Re: Expanding the Economic and Innovation Opportunities of Spectrum Through Incentive Auctions, GN Docket No. 12-268; Office of Engineering and Technology Releases and Seeks Comment on Updated OET-69 Software, ET Docket No. 13-26

The Expanding Opportunities for Broadcasters Coalition (the “Coalition”) hereby submits these Informal Comments pursuant to Section 1.1206 of the Commission’s rules. In these comments, we identify an outdated input used in the FCC’s *TVStudy* software that appears to undervalue the coverage area of many Class A television stations.

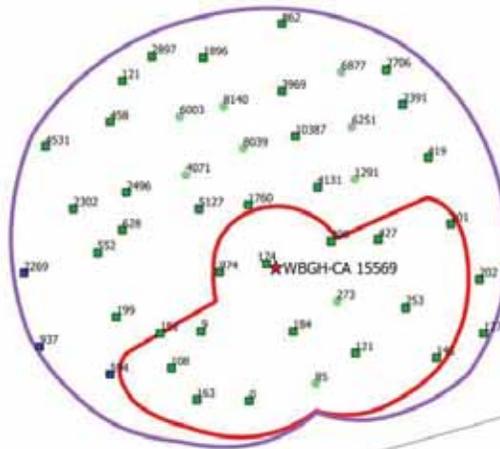
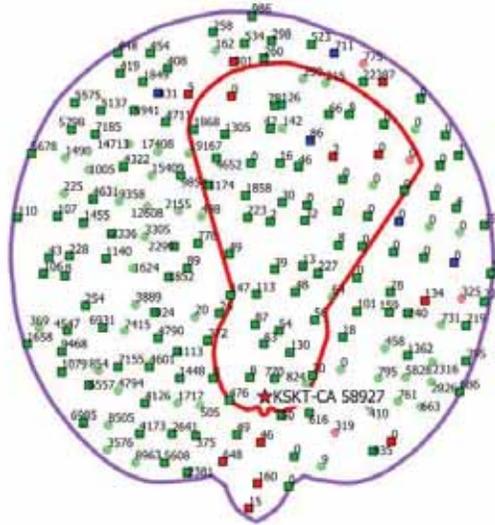
By failing to double the vertical antenna patterns for Class A stations, *TVStudy* undervalues the service and interference potential of some Class A TV stations.<sup>4</sup> For example, the *TVStudy* software predicts a 95.7% population loss for Station KSKT-CA (Facility ID No. 58927). Simply using the inputs that the Commission adopted in the *Digital LPTV Order*,<sup>5</sup> however, completely erases this coverage loss and produces a population count of 193,506—the exact population count produced by legacy OET-69 software. Similarly, doubling the Table 8 vertical field values reduces the 97.2% population loss for station WBGH-CA (Facility ID No. 15569) to just 1.5%. The following contour maps illustrate the effects of this approach—with the red lines showing the contours using the *TVStudy* default values and the purple lines showing the contours when following the approach adopted by the FCC in the *Digital LPTV Order*:

We urge the Commission to act promptly to revise the vertical antenna pattern inputs in *TVStudy* to reflect the same values that the agency has used for years to determine a Class A TV station's coverage and interference. Time is of the essence. Adopting this approach will affect the constraint files that the FCC will use in the auction for both Class A TV stations and full power stations (due to changes in incoming and outgoing interference). Accordingly, the Commission should make these changes as soon as possible so they do not interfere with the FCC's ability to conduct a successful Incentive Auction without any unnecessary delay.
